Item Name: 205 Skidtube bent detail

DESIGN #	DRAWN BY RH	DART AEROSPACE LTD HAWKESBURY, ONTARIO, CANADA	
CHECKED #	APPROVED #	DRAWING NO. D2580	REV. 0 SHEET 1 OF 3
DATE 07.02.27		TITLE 205 SKIDTUBE ASSEMBLY	SCALE NTS
A	96.09.16	NEW ISSUE	
B	96.12.02	AS MANUFACTURED	
C	98.08.26	REDRAWN, INCLUDED DEO 9094/9097	
D	07.02.27	CHANGE TO SS WEARPLATES AND GASKETS, INCLUDE DEO 9124/9183

DRAWING NO. D2580	TITLE 205 SKIDTUBE ASSEMBLY	REV. D	DART AEROSPACE LTD ENGINEERING ORDER	D.E.O. NO. D2580-D-1	SHEET NO. SHEET 1 OF 1	SCALE NTS
DRAWN <i>UP</i>	CHECKED <i>1</i>	MFG. APPR. <i>E</i>	APPROVED <i>MP</i>	DE APPR. <i>MP</i>		
DATE 10.09.22	DATE 10.11.04	DATE 10.11.04	DATE 10/11/04	DATE 10.11.04

CHANGE ALL WELDED CROSSBOLT SPACERS TO SWAGED SPACERS

SECTION D-D
SCALE 5:24

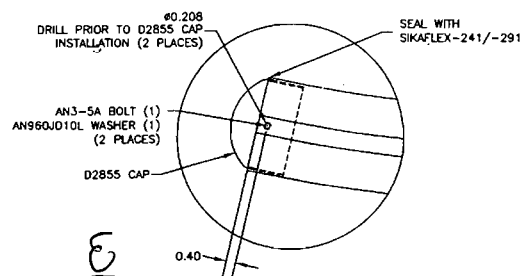
AFTER DRILLING AND BENDING ASSEMBLY
PERFORM THE FOLLOWING FOR Ø0.508 HOLES ONLY:

1. CHAMFER HOLE 0.050 X 45°
2. INSERT D2579 SPACER (20 PLACES)
3. WELD INTO PLACE AND GRIND FLUSH
4. C'BORE D2579 SPACER TO Ø0.437 X 1.00 DEEP

SECTION D-D & SECTION H-H ARE AMENDED AS FOLLOWS:

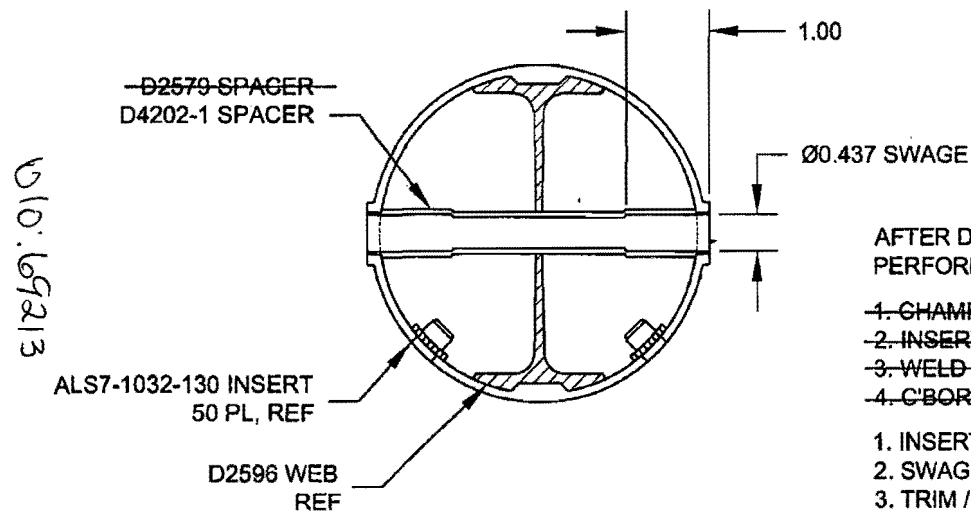
PARTS LIST IS AMENDED AS FOLLOWS:

WAS

QTY	QTY	PART NUMBER	DESCRIPTION
-041	-045		
20	24	D2579	CROSS BOLT SPACER

AFTER DRILLING AND BENDING ASSEMBLY
PERFORM THE FOLLOWING FOR Ø0.508 HOLES ONLY:

1. CHAMFER HOLE 0.050 X 45°
2. INSERT D2579 SPACER (20 PLACES)
3. WELD INTO PLACE AND GRIND FLUSH
4. C'BORE D2579 SPACER TO Ø0.437 X 1.00 DEEP

IS

20	24	D4202-1	SPACER
----	----	---------	--------

1. INSERT D4202-1 SPACER, 20 PL (-041) OR 24 PL (-045)
2. SWAGE TO Ø0.437 X 1.00 DEEP PER QSI 002
3. TRIM / GRIND FLUSH PER QSI 002
